Drainage Letter

RCH VALLEY

875 Valley Street,
Colorado Springs, Colorado

July 19th, 2024

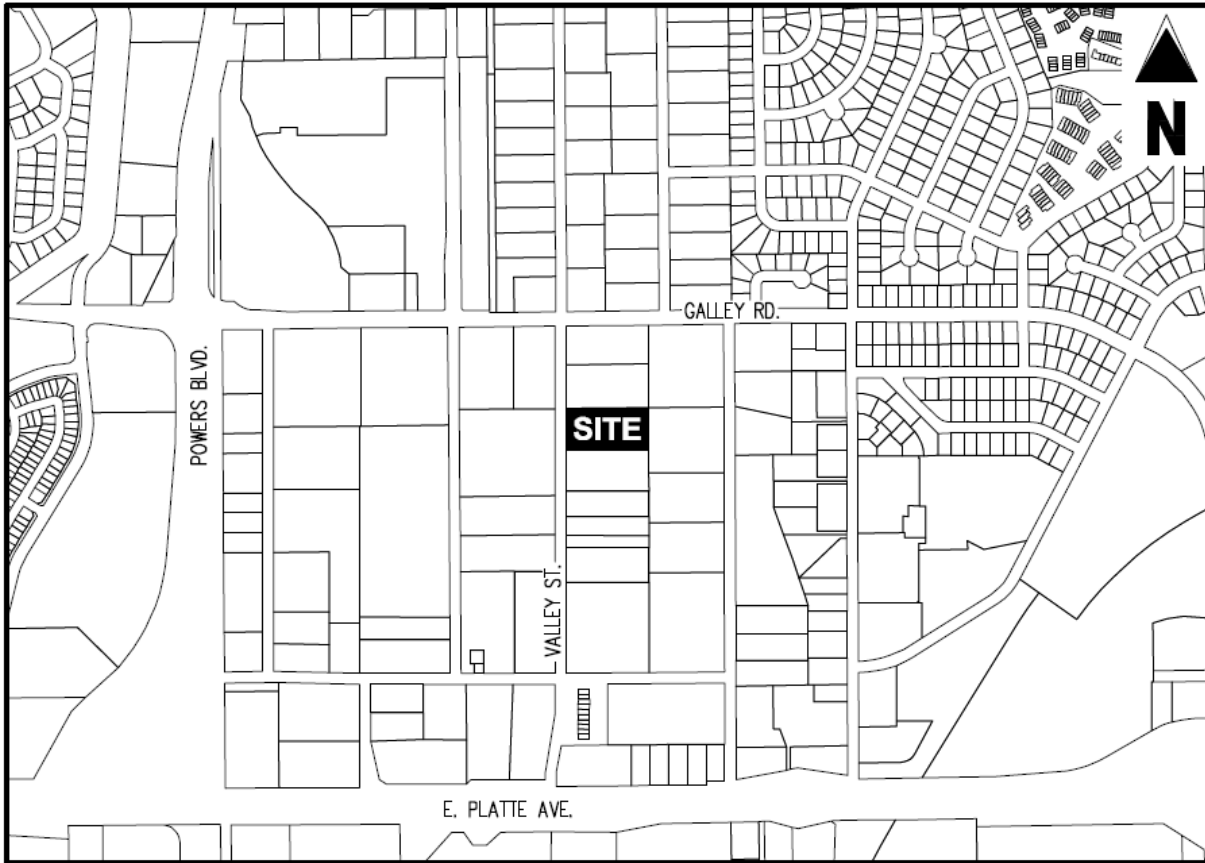
Please see drainage map
Please explain if new private storm drain lines are being routed from the building and into the street inlet.

DRAWING TITLE:
DRAINAGE PLAN

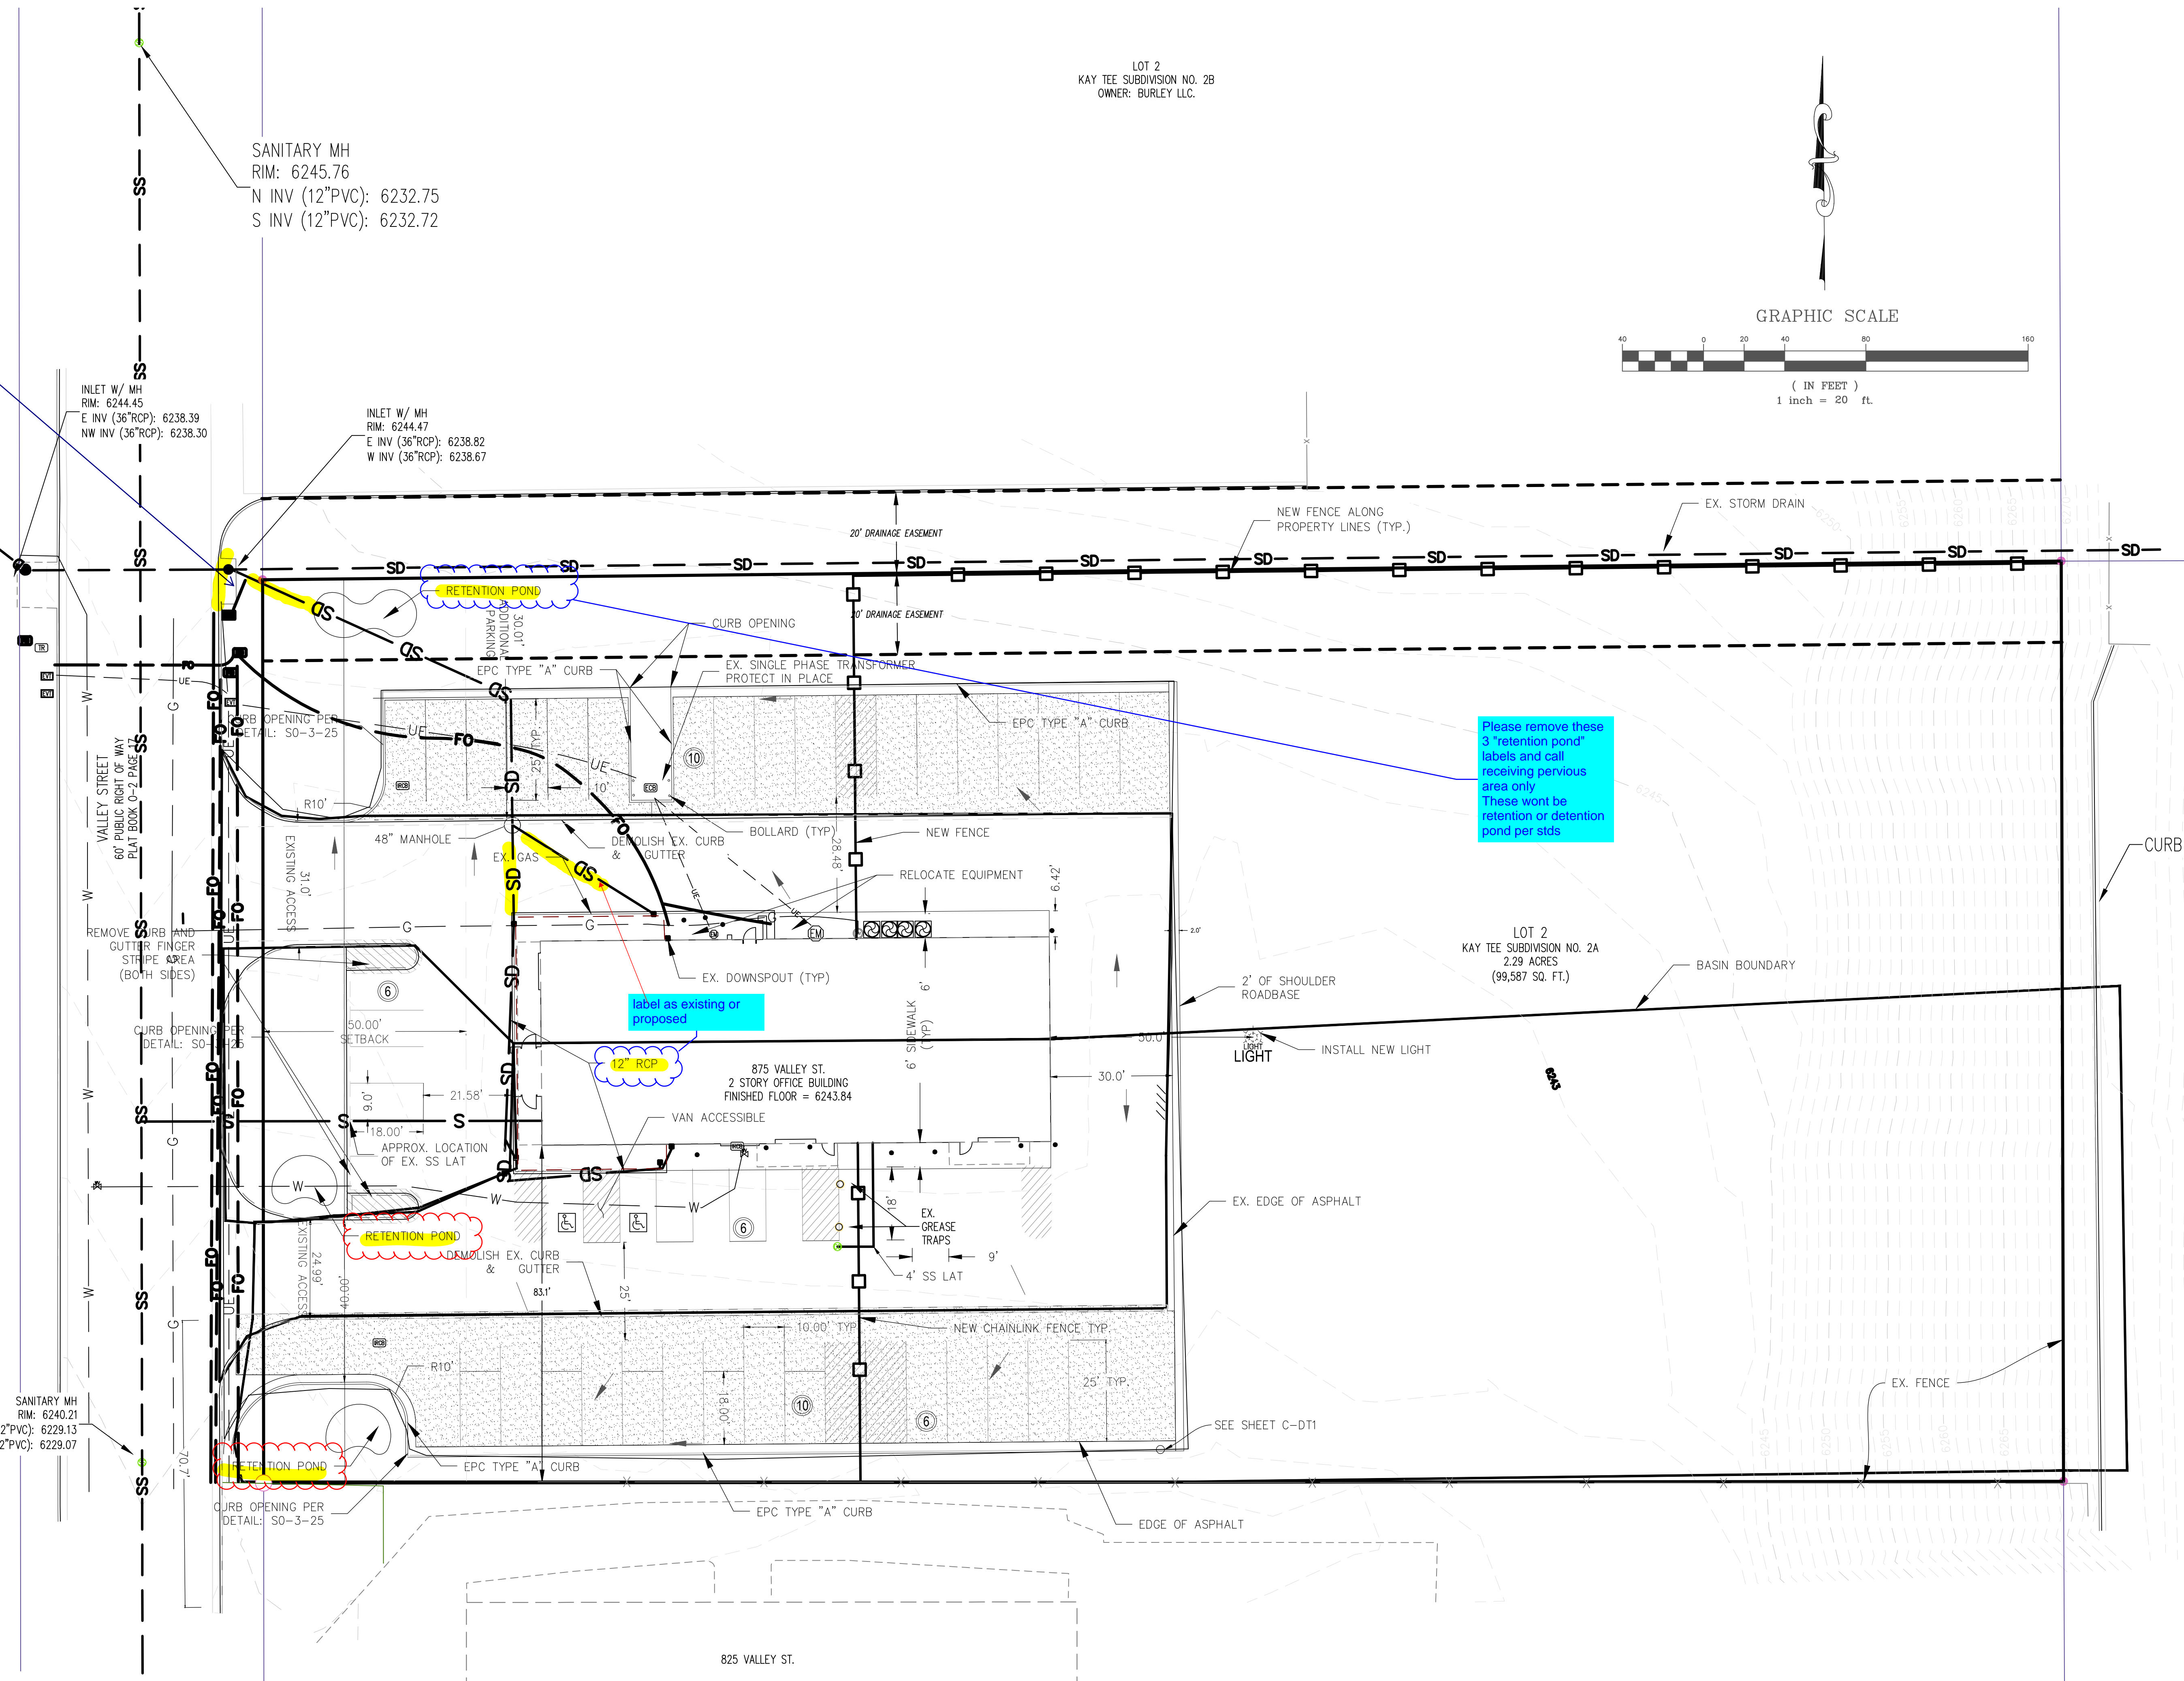
A work in the right permit will be required for connecting into the street inlet

Please remove these 3 "retention pond" labels and call receiving pervious area only. These wont be retention or detention pond per stds

label as existing or proposed
